DOCUMENT 006313.13 - REQUEST FOR INTERPRETATION FORM (RFI), BIDDING PHASE

1.2 PROJECT INFORMATION

- A. Project Name: Yurok Regional Wellness Center.
- B. Project Location: Weitchpec, CA.
- C. Owner: Yurok Tribe.
- D. Architect: Pyatok.

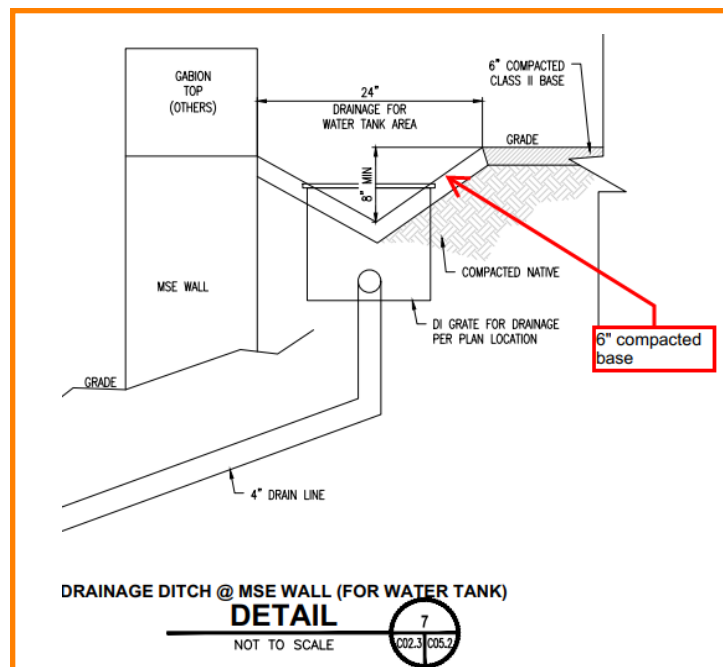
Sheet C0.25 shows the area by the two tanks being a base rock surfacing. The quantities show 62,403.41 sq ft of 4" base rock. Is this section included in that quantity and is in fact a 4" thickness? Does this area receive any fabric? Also there is a drainage swale on the lower section of the area. Please confirm this a rocked swale per 13B/C05.1, and not 13AC05.1.

The square footage is correct, however depending the application, the depths of the base will vary. Location for the 4" base depth would be for sidewalks, walkways, standalone equipment pads, (per existing and added details on C05.1 and C05.2 - see next sheet), and landscape areas that has decomposed granite walkways (such as areas behind rear parking lot).

All driving surfaces (including tank pad area) shall use 6" thick base depth. Geotextile fabric shall be added to all driving surface separating compacted soil to compacted base.

The drainage swale shall be compacted base per detail 7 on sheet C05.2 - which is forthcoming on Addendum E.

- A. Bidder: Mercer Fraser .
Email: ahunt@mercerfraser.com .
- B. Specification Section No.:
_____.
- C. Drawing Sheet/Detail Number: C03.3, Detail 1/C03.6 & Detail
4/C05.1 _____.

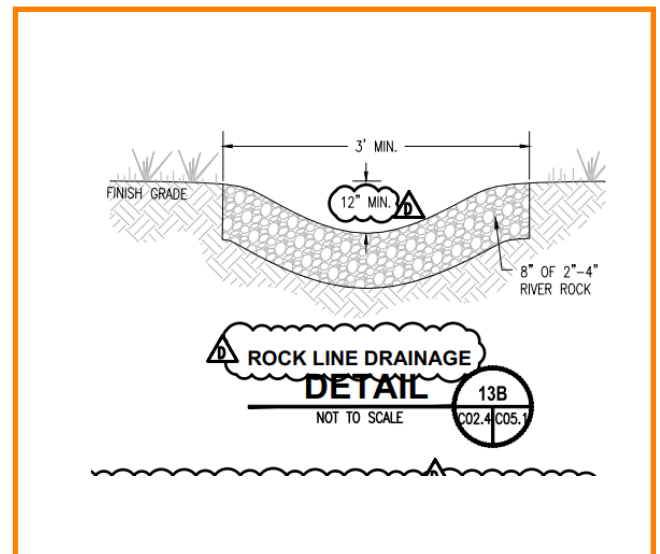
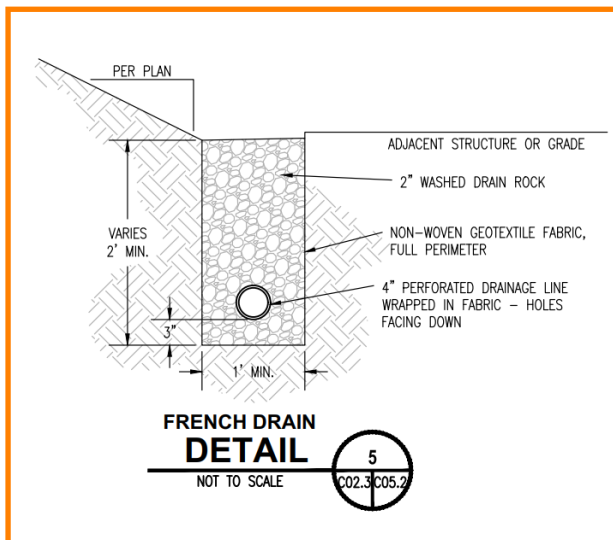
Sheet C03.3 shows various French drains behind walls and some that aren't behind any retaining wall features. Details 1/C03.6 and 4/C05.1 show what they look like behind the walls. Are there any other details or dimensions of how the French drain is elsewhere onsite? Also where the French drain daylight on the west side of the site, is this a dirt swale the water runs into?

The attached detail will be added to Addendum E plan set and should be used for areas that are not behind retaining structures.

Regarding beyond the day-lighting french drain: this will discharge into a rock lined ditch. Attached detail will also be added to Addendum E.

SHEET:
C03.3

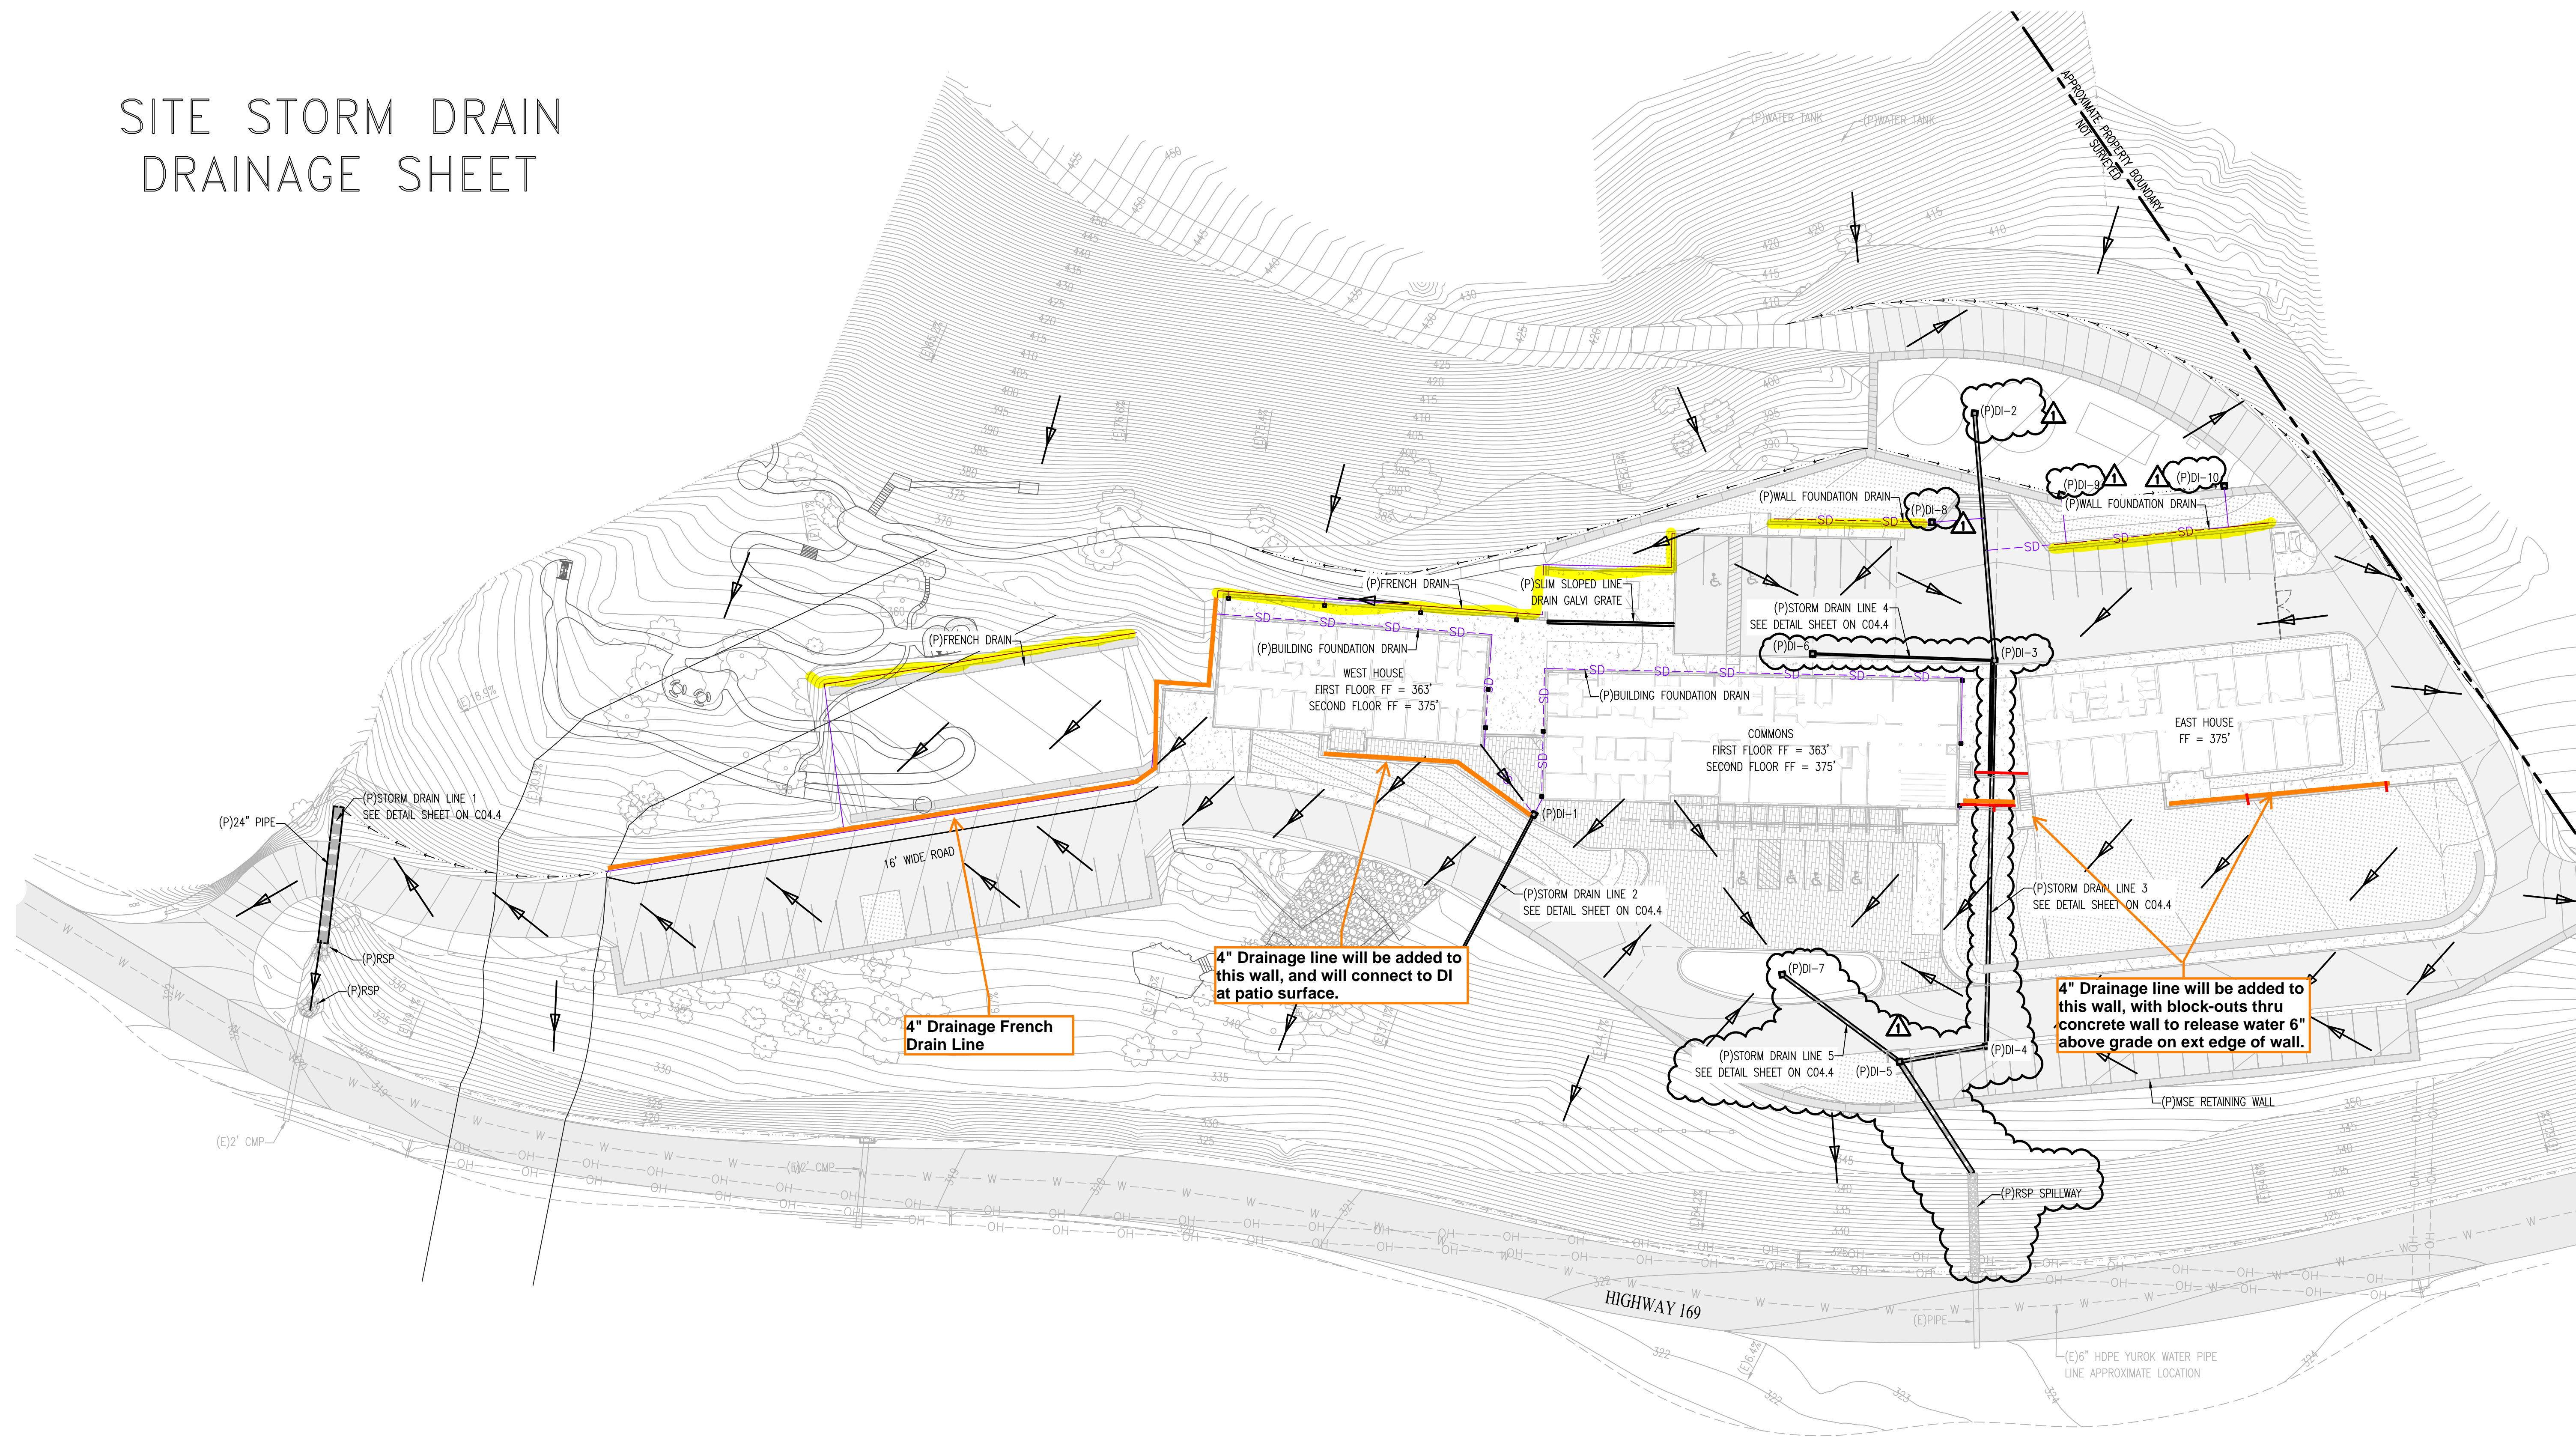
Please confirm that the highlighted areas on the attached C03.3 are the extent of fabric, perforated pipe and drain rock for the French drain system.

Please see attached dwg with confirmed area and added french drainage areas. These updates will be reflected in Addendum E plans.
